# **National Electrical Safety Code**

## **Interpretations**

**1961—1977 inclusive**

This edition includes official interpretations of the National Electrical Safety Code as made by the Interpretations Subcommittee of the National Electrical Safety Code Committee, ANSI C2.

Fig IR 173  
Line to pole clearance.

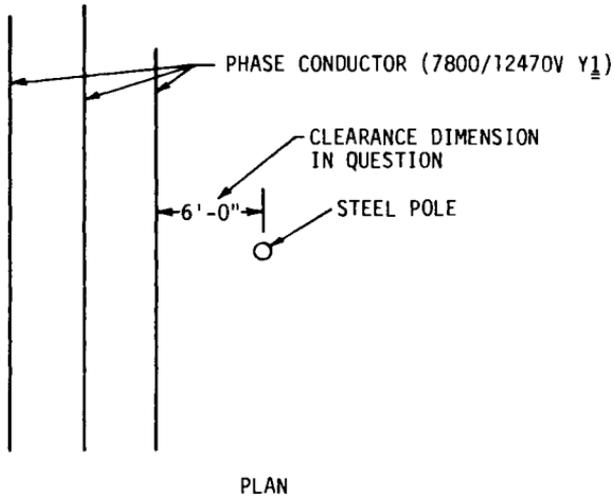
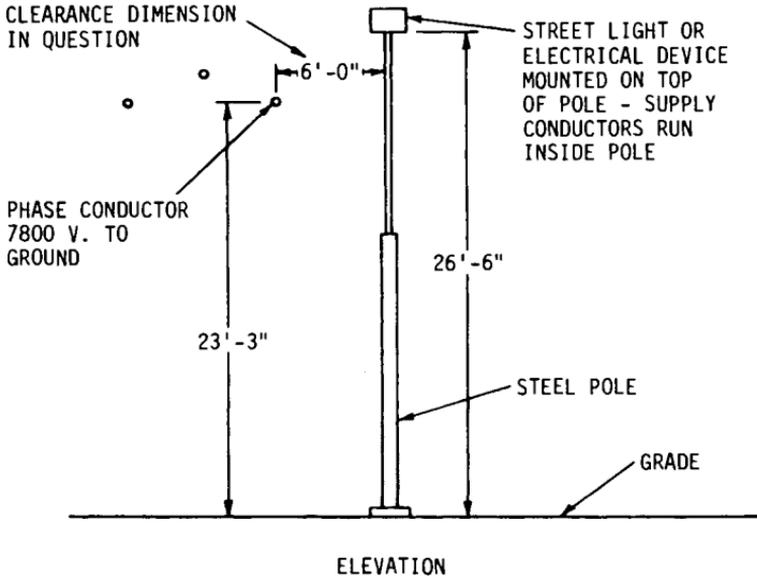
(1) Does Rule 234B1, "three feet if practicable," apply to the clearance between the steel pole and phase conductor of the installation shown on the attached sketch (Fig IR 173)? If not, what clearance rule is applicable to the installation?

(2) In reference to Rule 234C, Table 4, does the "voltage of supply conductors" refer to the *phase to ground* voltage of the *phase to phase* voltage of a 7200/12 470 volt grounded wye system?

Regarding your second question, the voltage of an effectively grounded circuit is the highest effective (rms) voltage between any conductor and ground (see definition 74 in Part 2, 1973 Edition of the NESC). If the 7200/12 470 grounded wye system is effectively grounded, the voltage of the circuit for the purpose of Table 4 is 7200 volts. If it is not effectively grounded, the voltage is 12 470 volts.

Fig IR 98

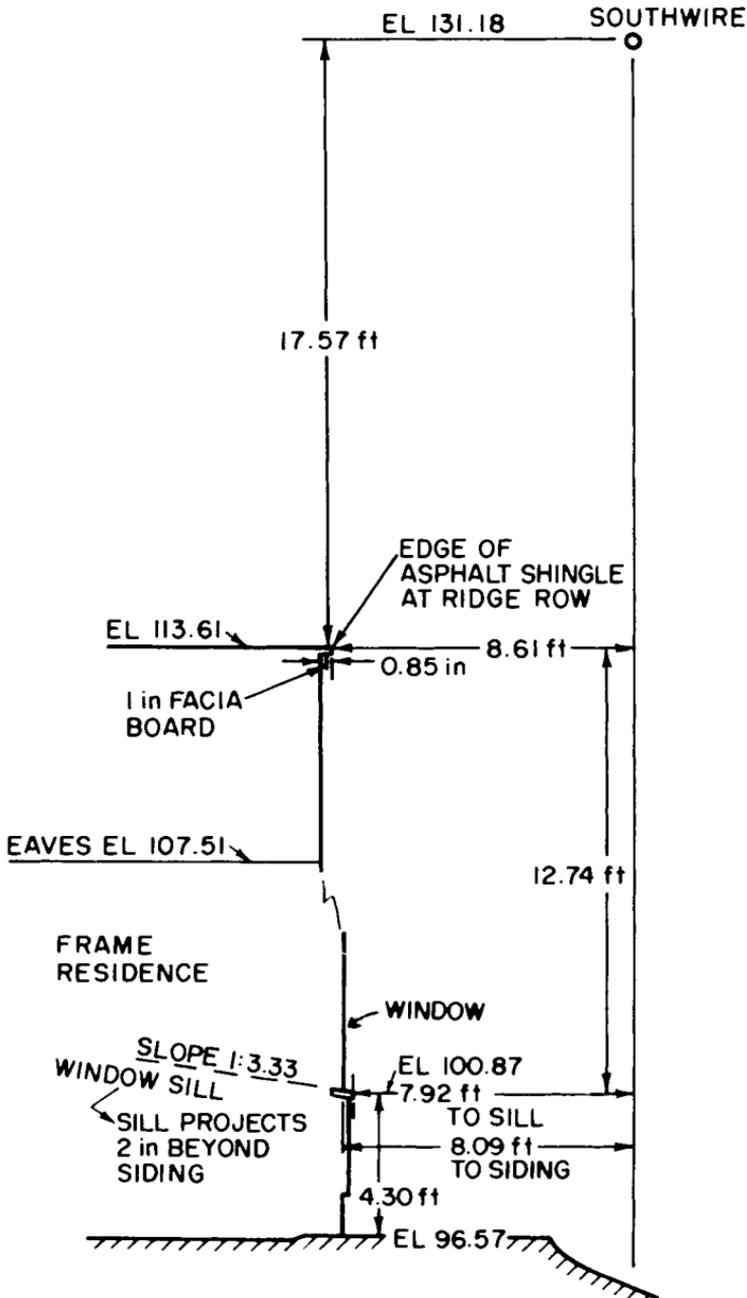
I am attaching a sketch of a residence. . .on which I have indicated the clearances from the nearest phase of a three phase, 12 470 volt overhead distribution circuit to a building. The vertical elevation of the building is indicated. . .on this map. You will note that the closest projected horizontal distance from this conductor to any part of the building, which in this case is a window sill projection, is 7.92 ft. You will also note that the vertical projected clearance to the closest part of this building is 17.57 ft.

Of course, in the revision of H32 which was revised by H81, the horizontal code clearance would only have to have been 3 ft.

Fig IR 172-1  
West elevation. (Scale: 1 inch = 5 feet.)

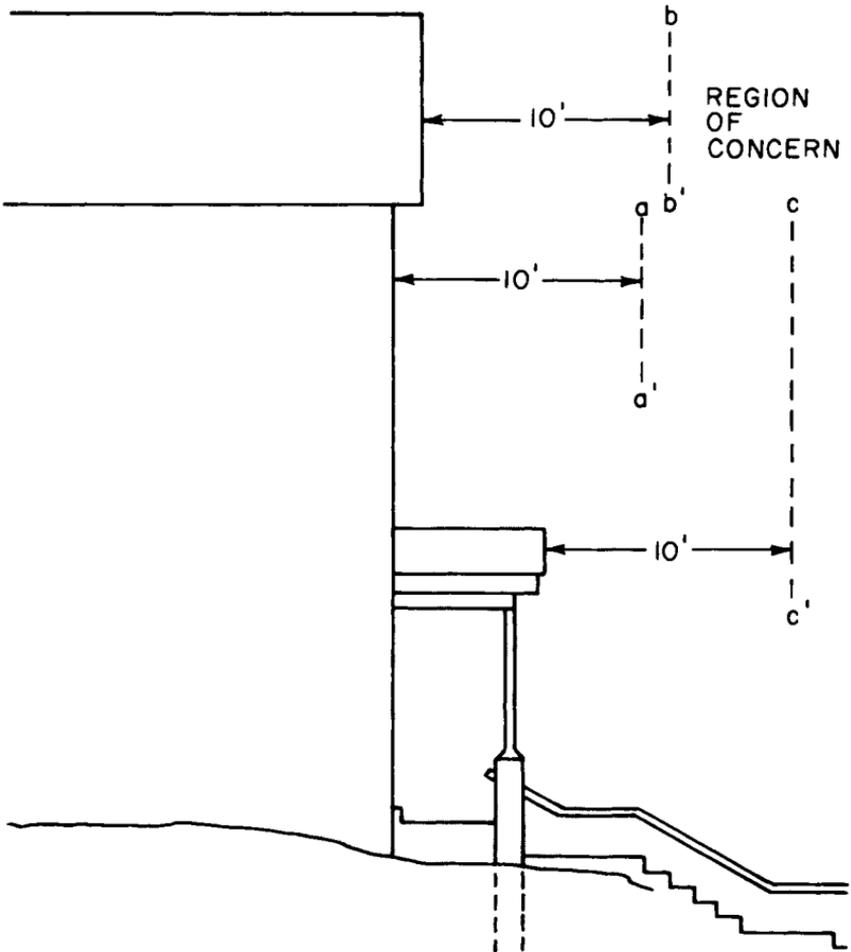
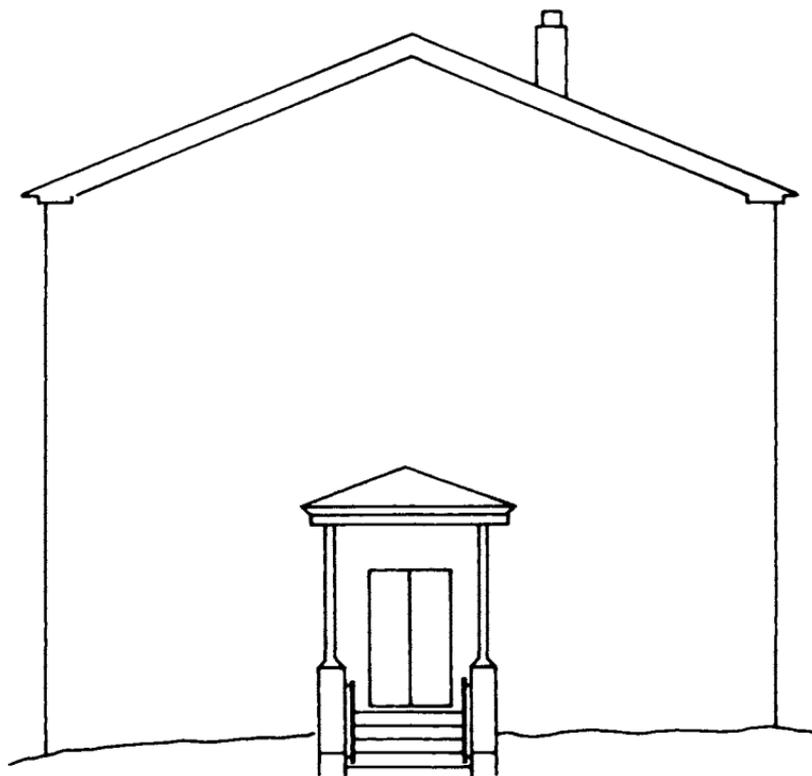
A 33 kV line is to be constructed to pass close to the front of an existing church. The height of the church is approximately 35 feet. The 33 kV lines will be between 25 and 35 feet above ground. The church has a porch that extends for 6.6 feet from the main structure. The main roof extends approximately 1.2 feet beyond the main wall. (See Figs IR 172-1 and IR 172-2.) The church is constructed of wood and the wall will require painting.

My query is: Is the horizontal clearance of 10 feet required for 33 kV lines measured from the nearest phase line to the roof lines to the side wall or to a vertical line through the front edge of the porch? That is, in Fig IR 172-1, from which of the three vertical lines, *aa'*, *bb'*, or *cc'*, should the minimum clearance of 10 feet for a 33 kV line be measured?

Fig IR 113

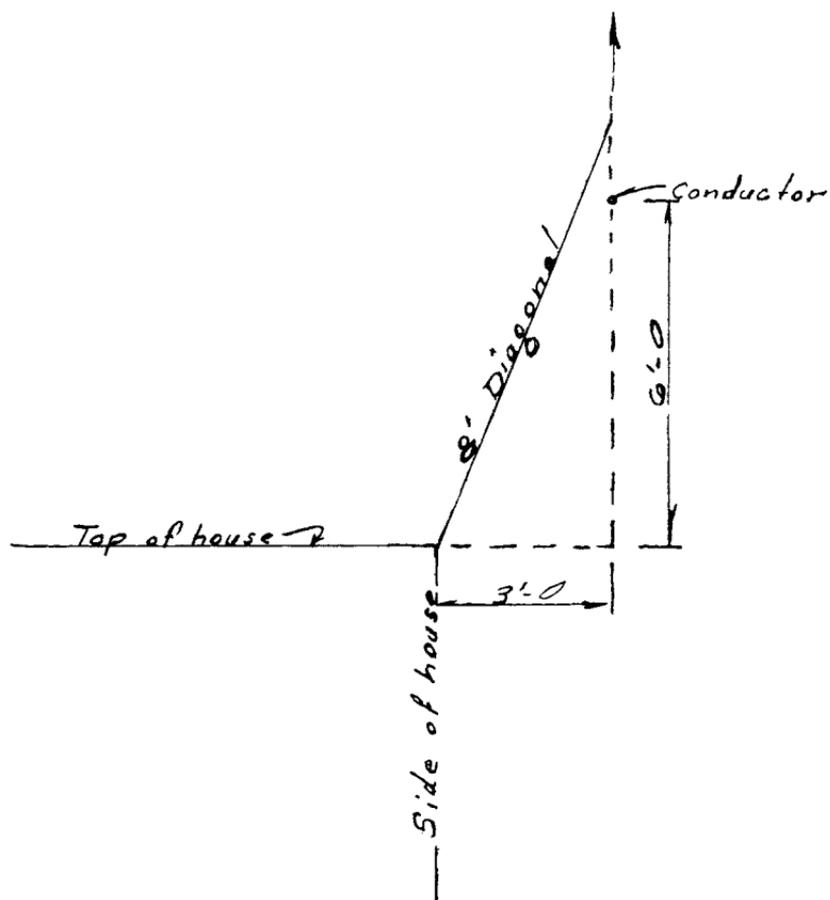
In Table 4, the clearance of supply conductors from buildings having voltages between 300 and 8700 V shows the horizontal clearance to be 3 ft and the vertical clearance to be 8 ft.

The case I have in mind where the conductor is above the building but not directly over it; for instance, the projected horizontal clearance of the conductor is 3 ft from the building and 6 ft vertically above this 3 ft projection point. As I understand it, in order to determine if the conductor has code clearance, you would have to project out from the top of the building a distance of 3 ft horizontally and project a line vertically to the conductor and if this was below the point where the 8 ft diagonal line from the nearest point of the building intersects this vertical projected line, then it would have code clearance to the building. This would mean that the conductor at the exact top of the building would be 3 ft horizontally from the building and on the vertical line from this point to where it intersects the 8 ft diagonal line and the diagonal clearance to the building would be something less than 8 ft. I am attaching hereto Fig IR-113 which is a sketch showing what I have in mind and it is my understanding that with the conductor at this location, it would have code clearance.

Fig IR 198

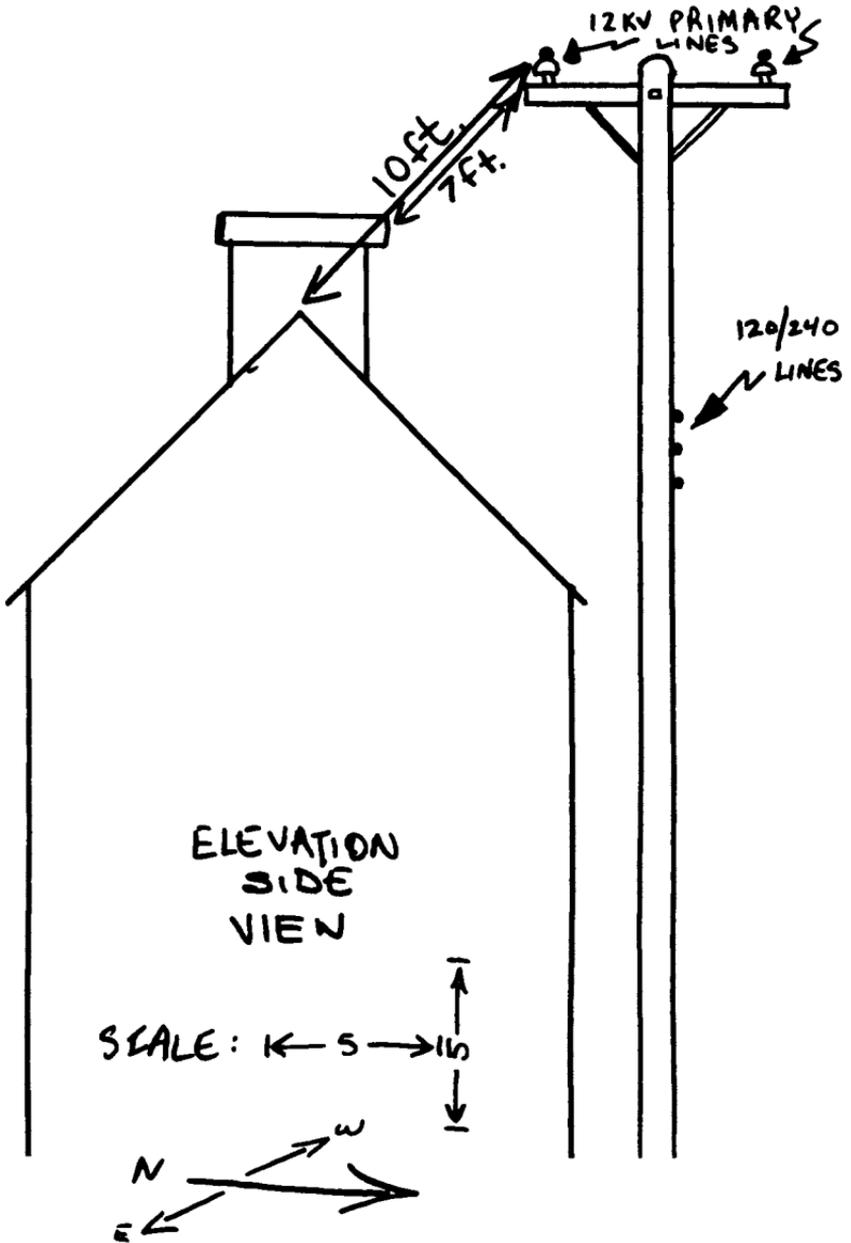
I have attached to this letter Fig IR 198 which may assist in a better understanding of these facts.

Query: Does the chimney atop the roof of the house constitute an "attachment" within the meaning of the National Electric Safety Code section 234C4(a) such that the clearance of less than eight feet from the chimney to the 12 kV primary line violates National Electrical Safety Code 234C4(a)(1)?

Fig IR 102.

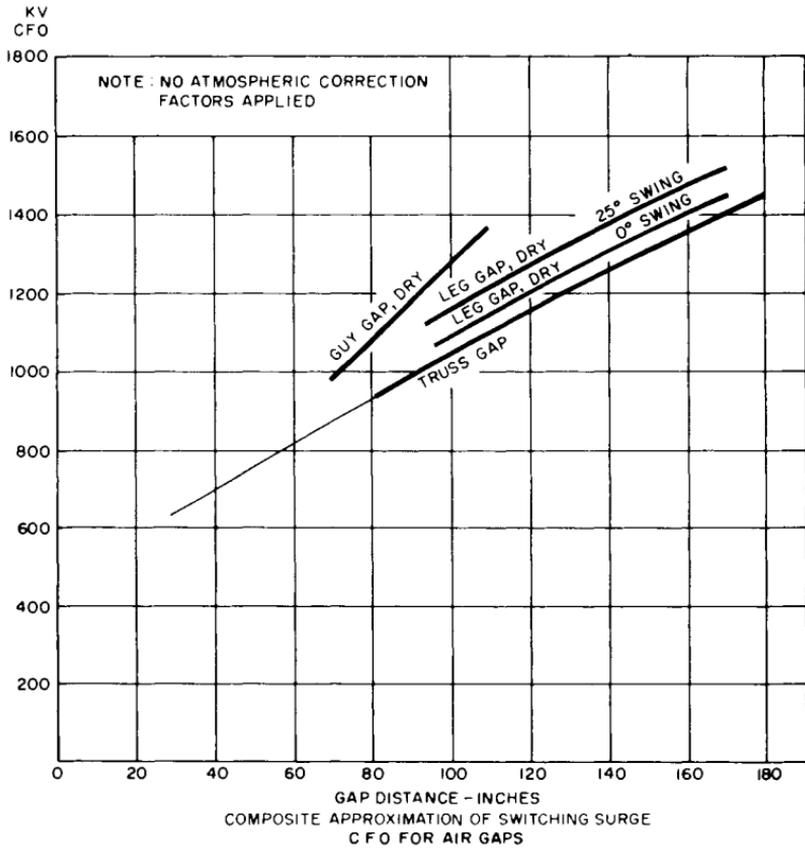
This value of clearance appears to be very unreasonable when considering that the guying on metal EHV guyed towers is actually a structural member. It appears that the clearances to structures would more readily apply. Electrical tests at both 345 and 500 kV on full scale structures have verified that the point to point striking distance from conductor to guy is electrically greater than the point to plane effect existing from conductor to the structure. These are evident as shown in the attached copy of Fig IR-102.

In view of the possible savings and the effect on the rate base, we are respectively requesting a clear interpretation of Rule 235A3, Table 9, in covering the conductor to guy clearances on guyed metal EHV structures. As representatives of eleven utility companies which are cooperating with the Tennessee Valley Authority in a 1500 mW diversity interchange, we have been authorized to prepare any exhibits or examples, provided it is necessary for your use in interpreting Rule 235 in connection with guyed EHV metal towers.

In view of the possible savings that can be realized with guyed EHV metal towers and the fact that utilities are presently installing such towers on both 345 and 500 kV lines, it would be desirable to the industry to obtain a clear interpretation of the intent concerning Rule 235 and its application on EHV metal towers. Various members of the C2 Sectional Committee have indicated that when the Sixth Edition of the code was being reviewed for revision, the subject of EHV was not considered for Rule 235. Rule 235 applies primarily on pole lines and Handbook H43 indicates that the separation required is increased by an increment which is determined by sparking distance in air. Actual service experience and many tests have shown that the same striking distance to guy, as allowed to the crossarm on a guyed EHV structure, is electrically of greater value because of the point to point effect as compared to the point to plane effect. Actually, the guy on a metal EHV guyed structure is a structural component, and clearances as outlined to surfaces of crossarms or surfaces of poles would be more applicable. In addition, considering voltages on the basis of single line to ground instead of conductor to conductor would be more reasonable.

Drawing of example:

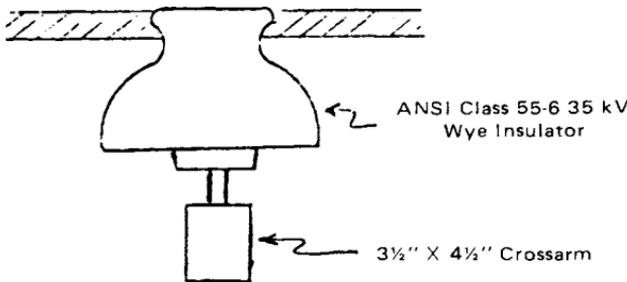
a) Please clarify the meaning of minimum clearance, in particular as related to a pin type insulator of larger diameter than the cross-arm on which it is mounted. Is the minimum clearance the straight line ruler distance measured as though the insulator were not there or the total intervening surface length between conductors and support surface (flashover distance)?

Fig IR 176-3. (1) Does climbing space extend into this stinger wire if mounted in the position of stinger A? (2) Does climbing space extend into this stinger wire if mounted in the position of stinger B?

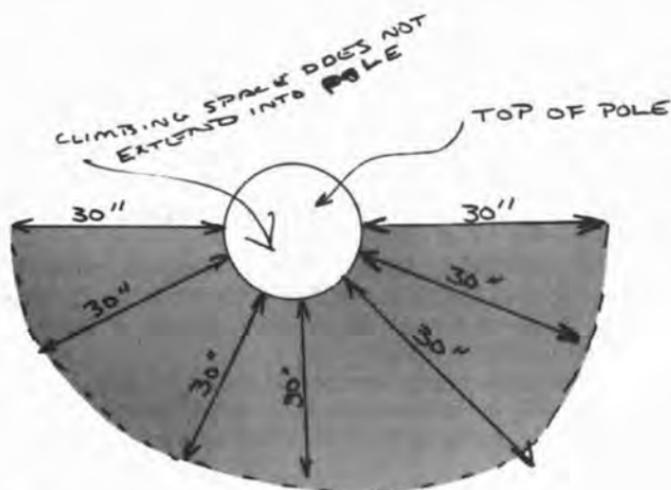
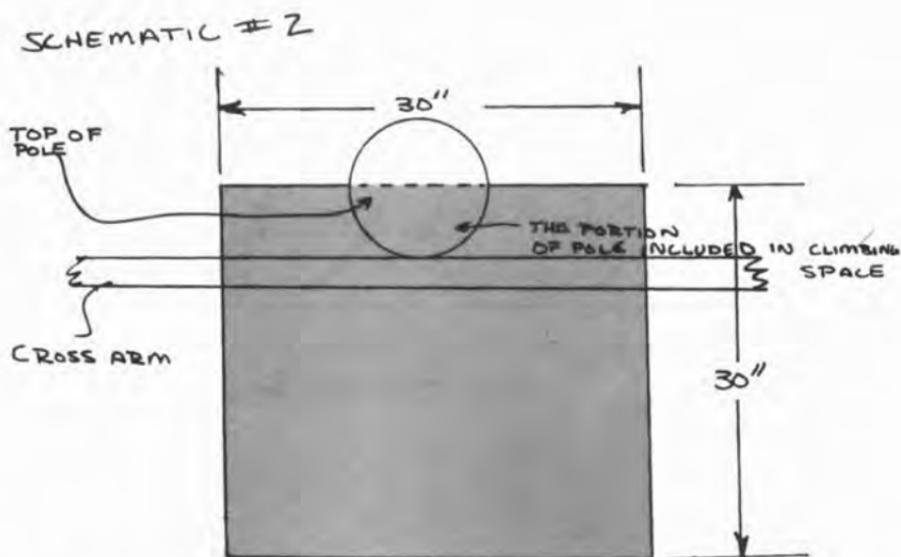
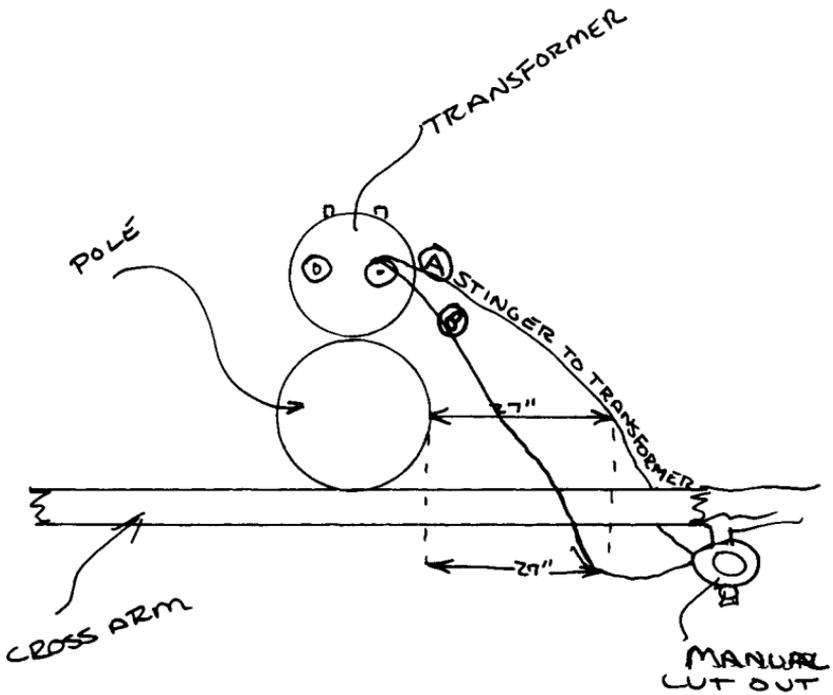
Further in this Code. . . Rule 236B. . . states that when the pole or structure is included in the climbing space it does not obstruct the climbing space and from my interpretation gives me a configuration described in Fig IR 176-2.

Fig IR 176-3 is the actual configuration in question, and I would like to know if the stinger wire from the bottom of the manual cutout would be considered in the climbing space as specified by the Code.

With respect to your implied question regarding Fig IR 176-2, please note that Rule 236 says, "Portions of the pole or structure, when included in *one side or corner* of the climbing space. . ." Fig IR 176-2 would be acceptable without the crossarm, but not as shown.

With respect to Fig IR 176-3, neither stinger wire *A* nor *B* extends into the climbing space if the space is provided on the left side away from the stinger wires. As Exception 1 to Rule 236E1 points out, these requirements for climbing space do not have to be met if the line is already de-energized before workmen climb the pole in question.

Fig IR 127-1.

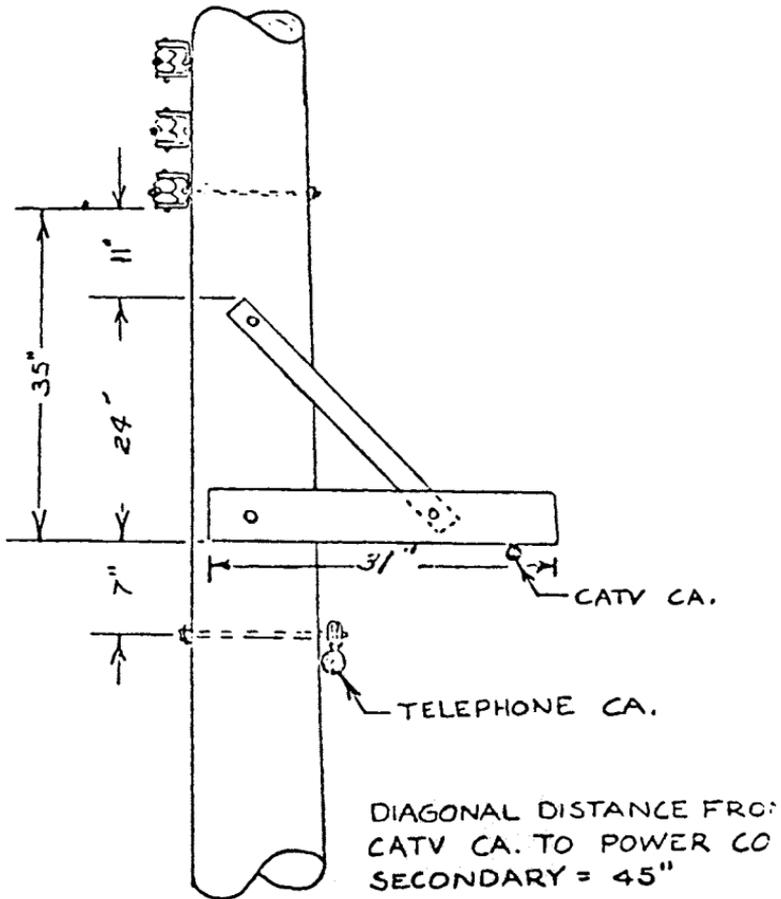
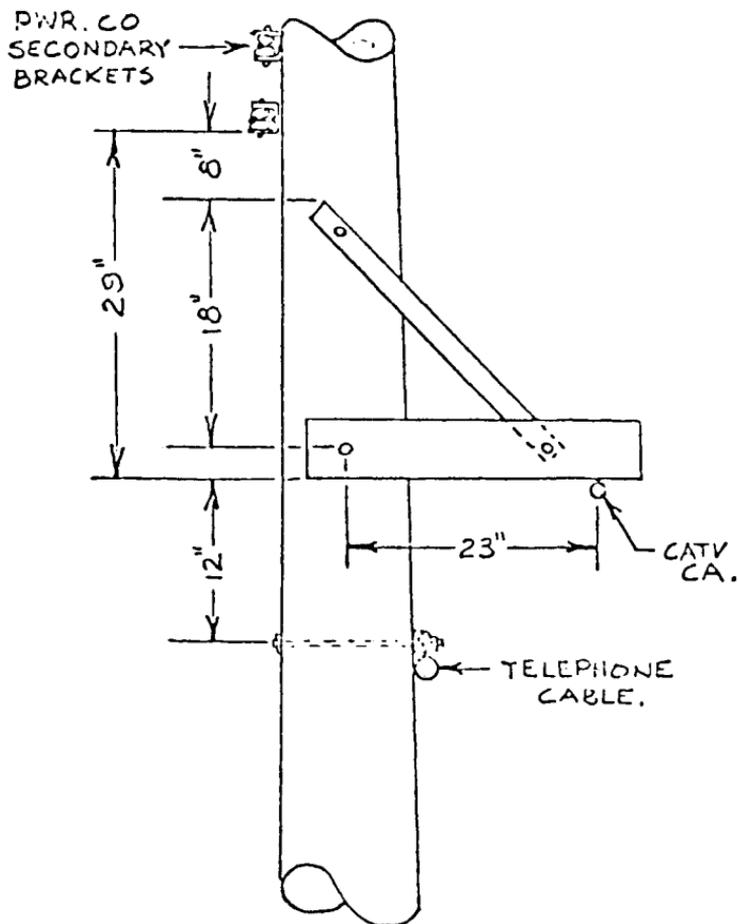
We are enclosing information on two locations where in order to attempt compliance with Rule 238, a CATV operator used a cross arm to support their cable. We would appreciate an interpretation on whether or not the requirements of Rule 238 are being met on these two examples.
